寄件者: Vivian Wai [REDACTED]
寄件日期: 2026年08月12日星期三 15:03
收件者: tpbpd/PLAND
副本: Andrea Wing Yin YAN/PLAND; Ivan Sze Yuet FUNG/PLAND; Athena Pui Yin LAI/PLAND; Yen PY LEUNG/PLAND
主旨: S. 16 Planning Application No. A/YL-KTN/1254 - Departmental Comments
附件: LD-L1047A-BP01.pdf; KTN1254_回應部門意見(10Aug2026)古蹟辦.pdf; KTN1254_回應部門意見(10Aug2026)漁護署.pdf; LD-L1047A-DS01A (Report).pdf

Ref. S. 16 Planning Application No. A/YL-KTN/1254 - Departmental Comments

Stormwater Drainage Design

Report No.: **LD/L1047A/DS01A**
Date: **11/8/2026**

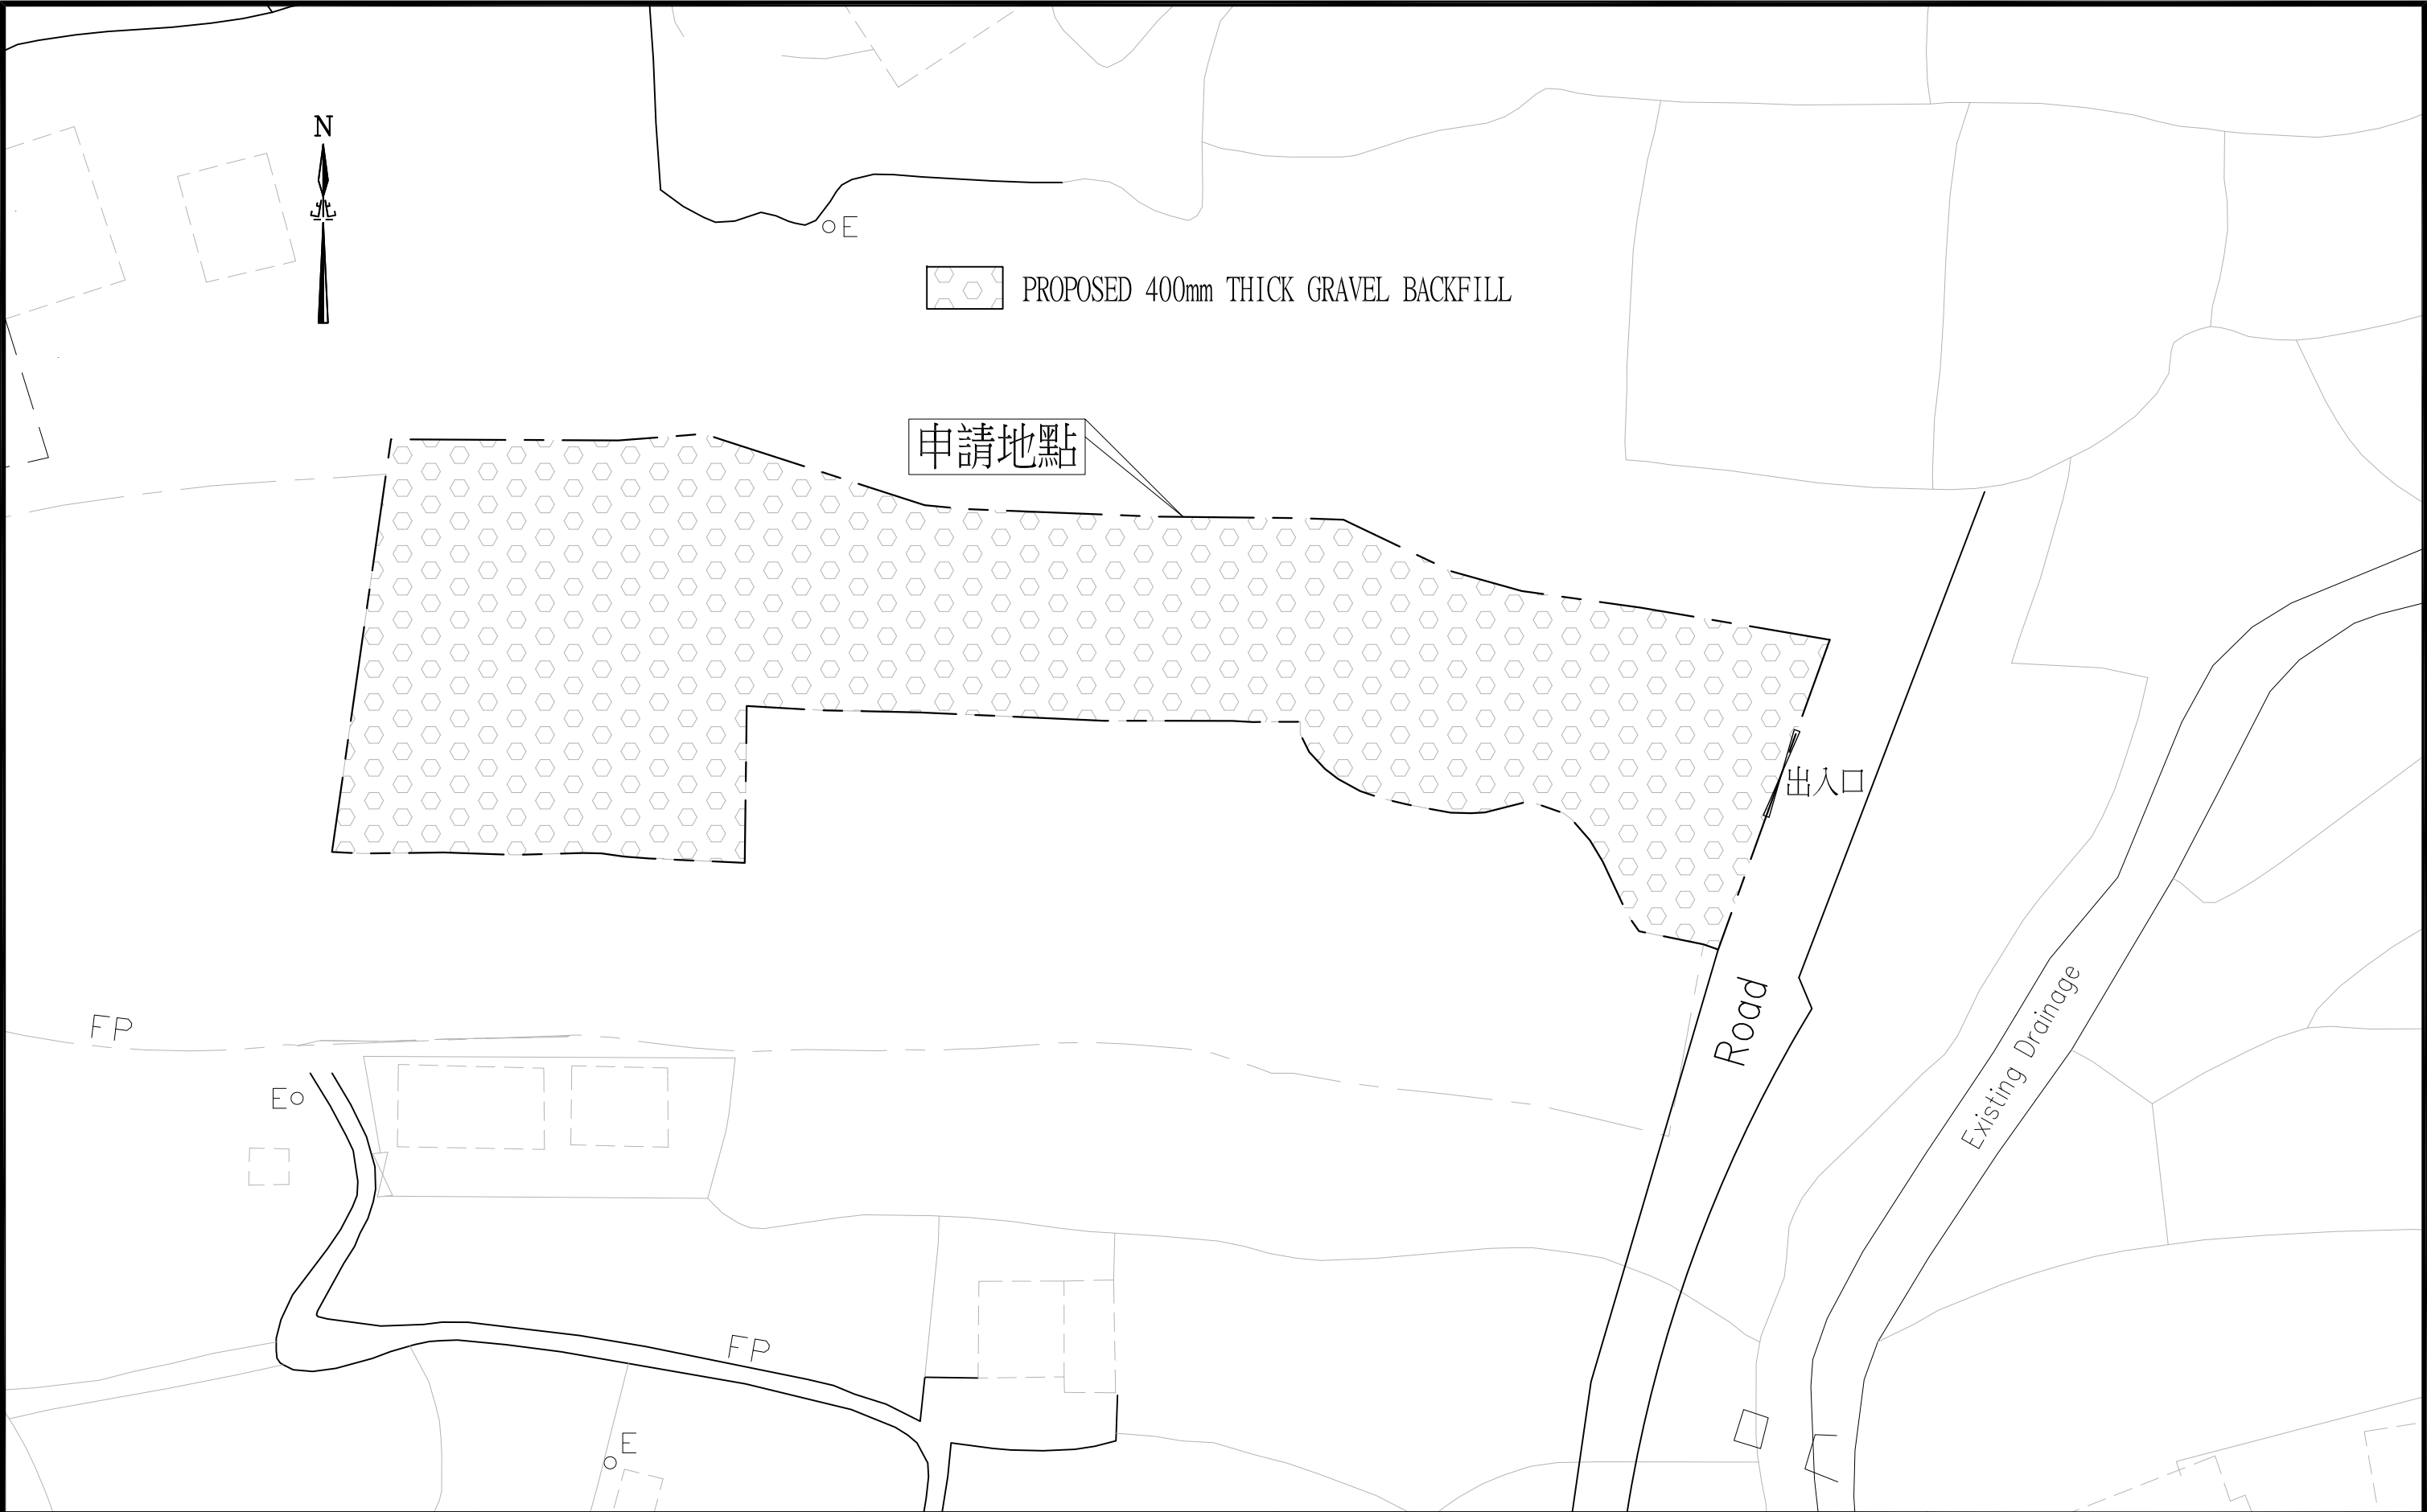
The application site ("the Site") falls within Tai Kong Po Site of Archaeological Interest (SAI). According to the submission, ground excavation for catchpits and 300-375mm u-channels will be carried out along the site periphery. According to the previous archaeological works at the Site, archaeological remains from Song, Ming and Qing dynasties were unearthed underneath a shallow topsoil about 10-15 cm thick.

Considering the archaeological significance of the SAI and the presence of findings immediately under ground level, AMO has concerns on the possible impact from the proposed works on the SAI. The applicant is advised to explore no further excavation (including but not limited to site formation works, drainage works, sewerage works, construction of septic tank, etc.) when carrying out the proposed development at the Site. If excavation is found unavoidable, the applicant is required to conduct an Archaeological Impact Assessment (AIA), which includes a baseline review and field investigation, to evaluate the archaeological impact to be imposed by the proposed development and its associated works. Should the AIA involve fieldwork and excavation, the applicant shall engage an archaeologist to apply for a licence under the Antiquities and Monuments Ordinance, Cap. 53. An Archaeological Action Plan shall be submitted to AMO for agreement before the licence application. Subject to the findings of the AIA, appropriate mitigation measures, if needed, shall be recommended for agreement by AMO and implemented by the applicant to the satisfaction of AMO.

在考慮考古遺址造成的影響而言，在進行該地塊的擬建開發項目時，不會進行任何進一步的開挖工程，亦沒有污水工程及化糞池建造等。申請場地內排水工程內的 300 至 375 毫米 U 型溝渠和集水坑，是會以 U 型預製件，完全取消向下挖掘的地面開挖工程，改為在地面上置放式混凝土明渠。

1. 工程首先是會在現有地面上加固防護，先在表土上方鋪設一層地質織物 (Geotextile) 或細沙，作為保護層，以作為地面物理隔離與緩衝，防止上層填料與原生表土混合。在原土地上方進行輕量化施工，透過取消地下開挖並全面改為地面輕量化施工，能大幅降低對潛在考古遺址的破壞。
2. 本項目僅為「臨時」用途，改為在地面上置放式混凝土明渠是具備完全還原，由於所有設施（預製明渠、以地面鋪墊方式及地質織物）均為地面置放，當臨

(1)排水建議圖

(2)填土位置圖

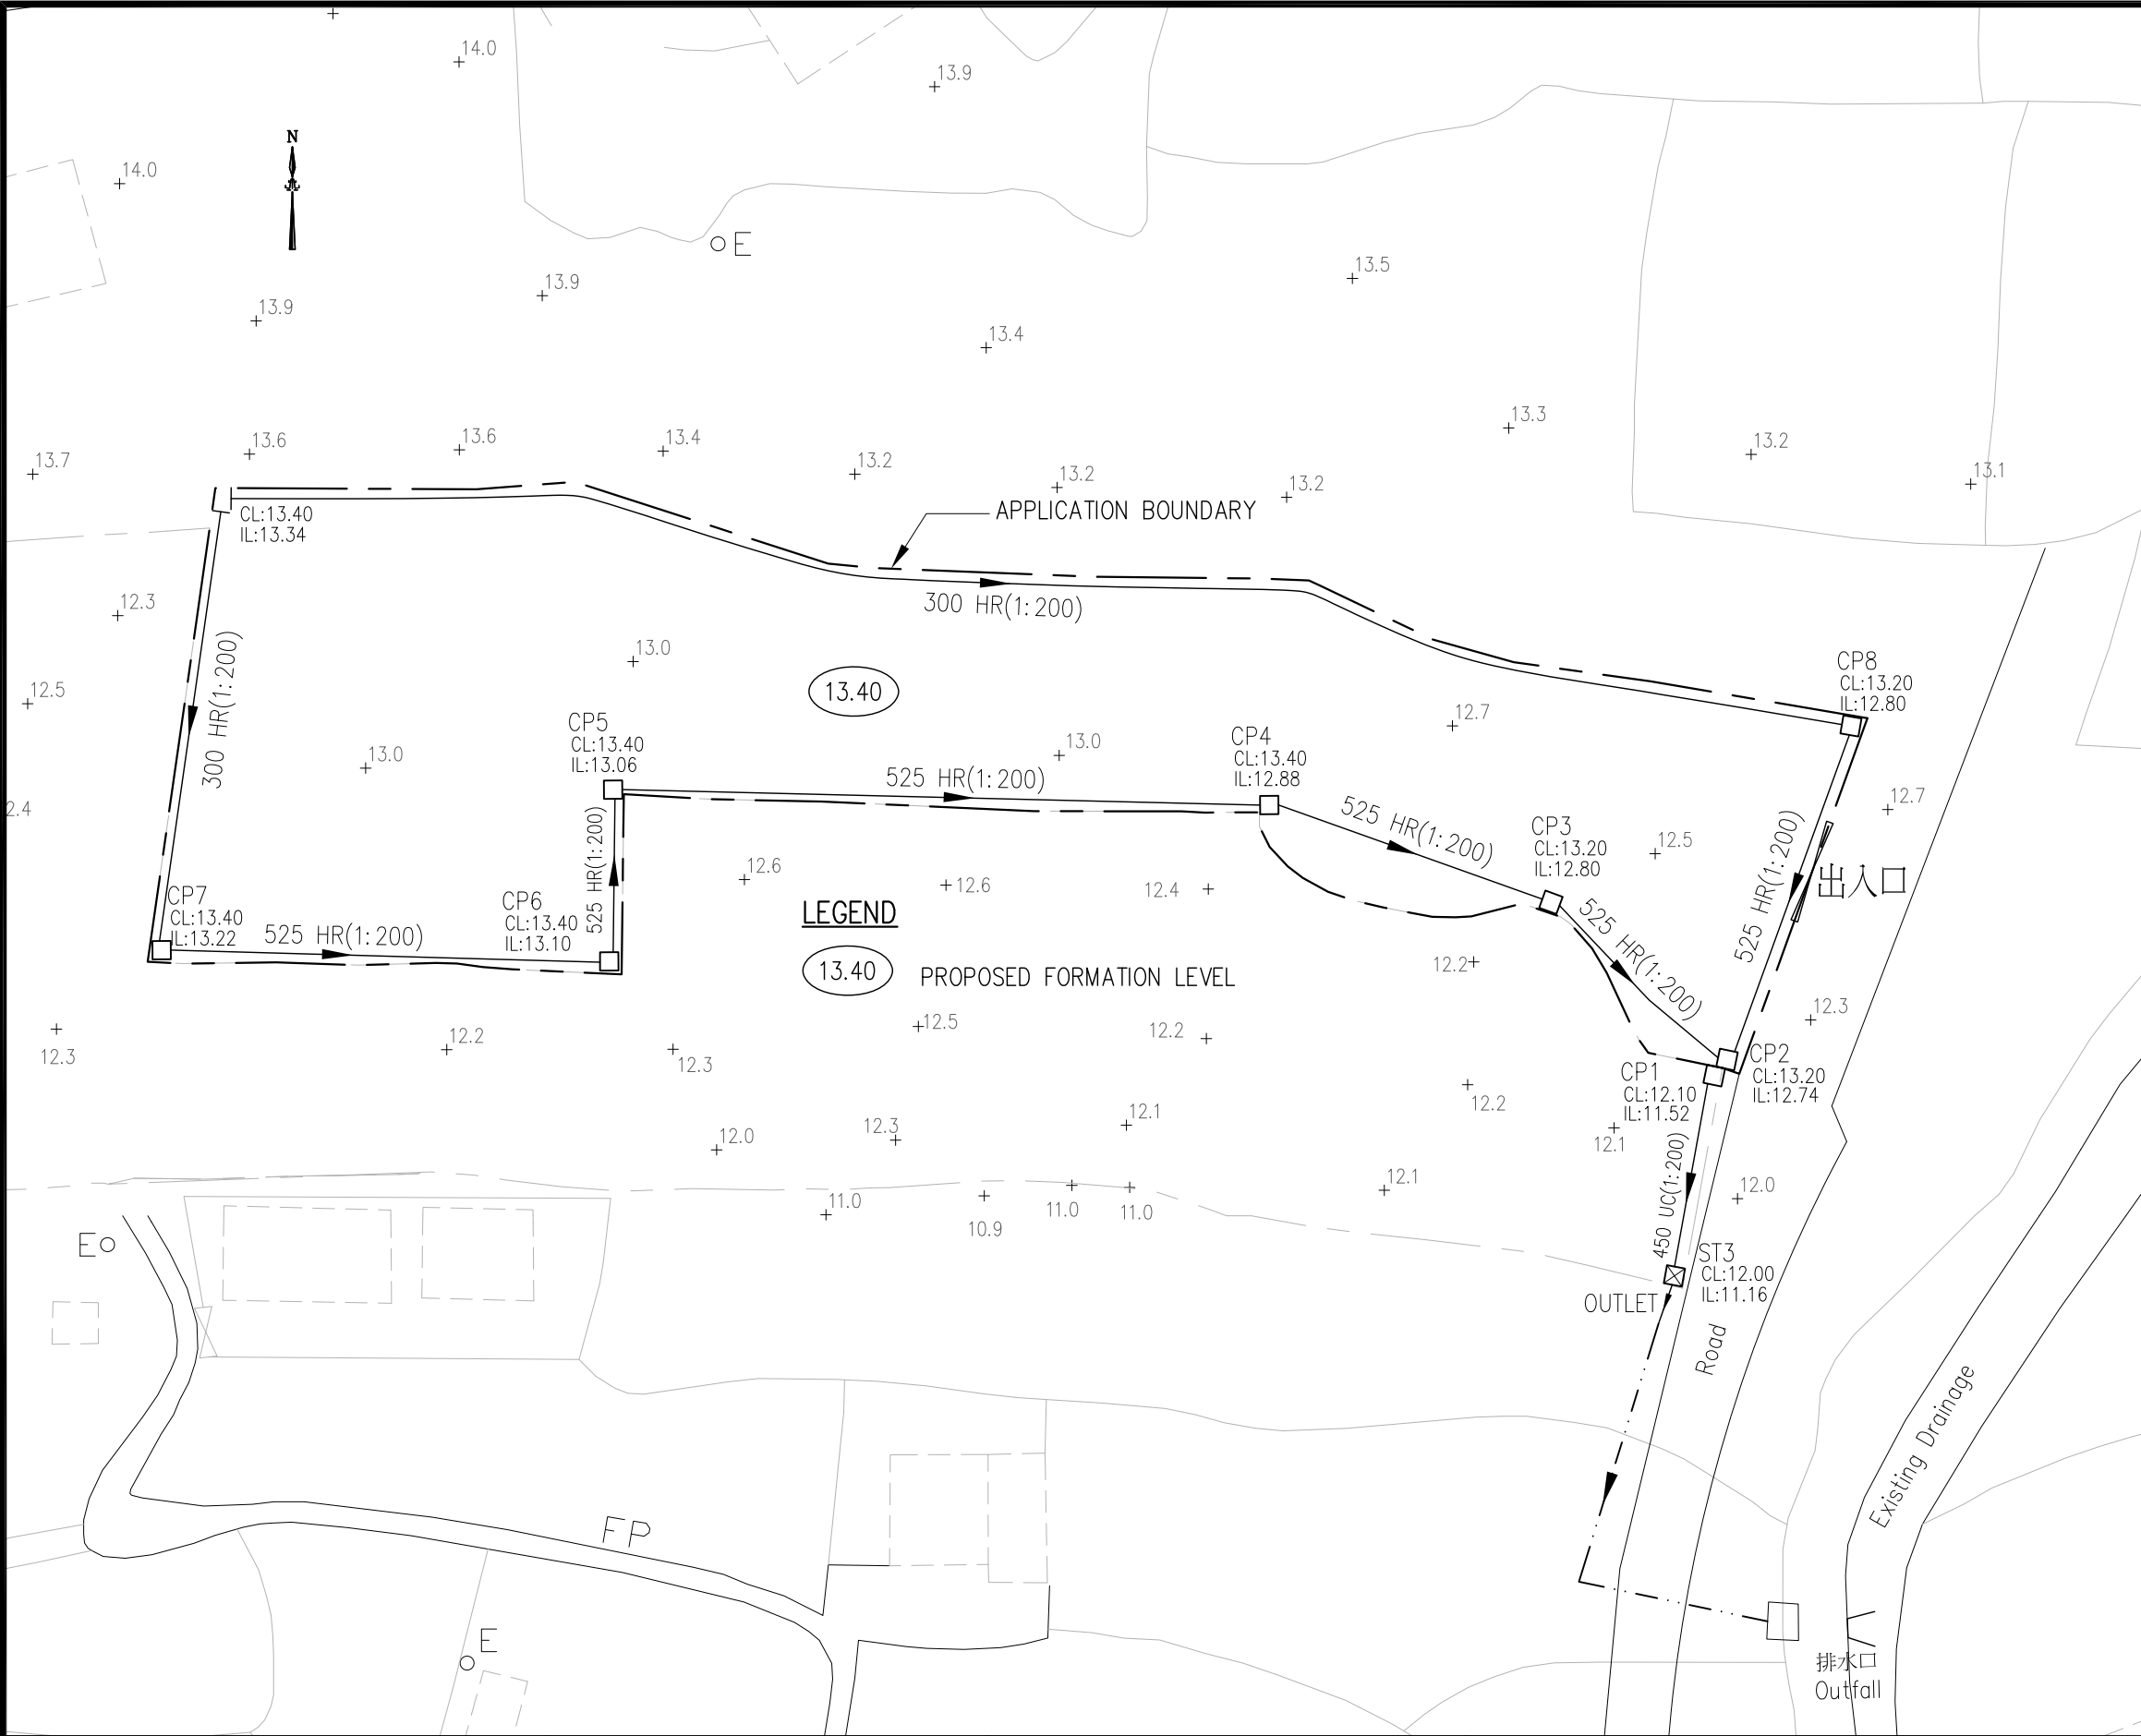
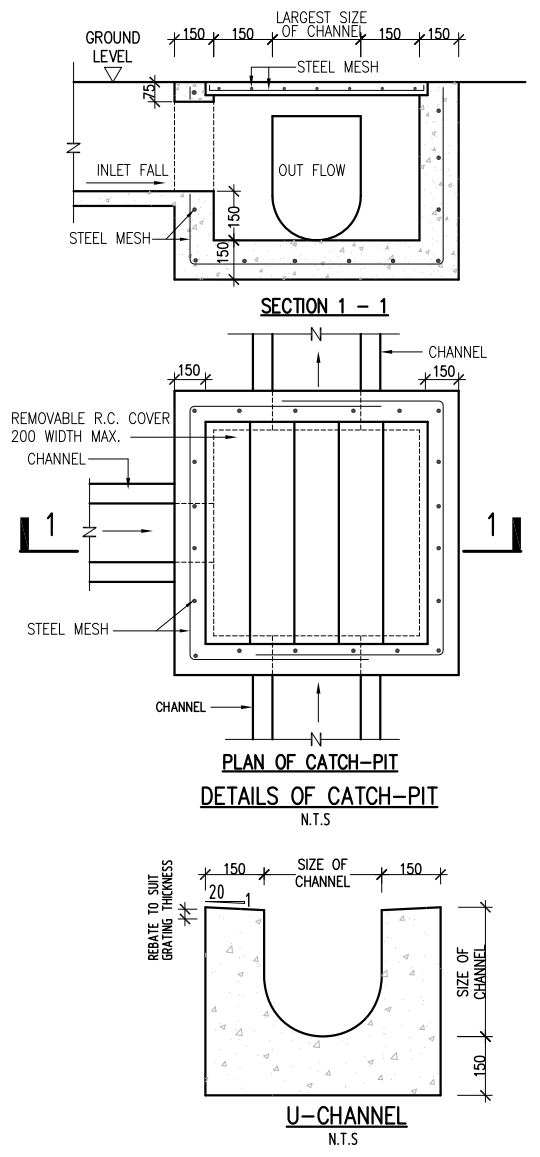
The application site ("the Site") falls within Tai Kong Po Site of Archaeological Interest (SAI). According to the submission, ground excavation for catchpits and 300-375mm u-channels will be carried out along the site periphery. According to the previous archaeological works at the Site, archaeological remains from Song, Ming and Qing dynasties were unearthed underneath a shallow topsoil about 10-15 cm thick.

Considering the archaeological significance of the SAI and the presence of findings immediately under ground level, AMO has concerns on the possible impact from the proposed works on the SAI. The applicant is advised to explore no further excavation (including but not limited to site formation works, drainage works, sewerage works, construction of septic tank, etc.) when carrying out the proposed development at the Site. If excavation is found unavoidable, the applicant is required to conduct an Archaeological Impact Assessment (AIA), which includes a baseline review and field investigation, to evaluate the archaeological impact to be imposed by the proposed development and its associated works. Should the AIA involve fieldwork and excavation, the applicant shall engage an archaeologist to apply for a licence under the Antiquities and Monuments Ordinance, Cap. 53. An Archaeological Action Plan shall be submitted to AMO for agreement before the licence application. Subject to the findings of the AIA, appropriate mitigation measures, if needed, shall be recommended for agreement by AMO and implemented by the applicant to the satisfaction of AMO.

現附上新圖及排水報告
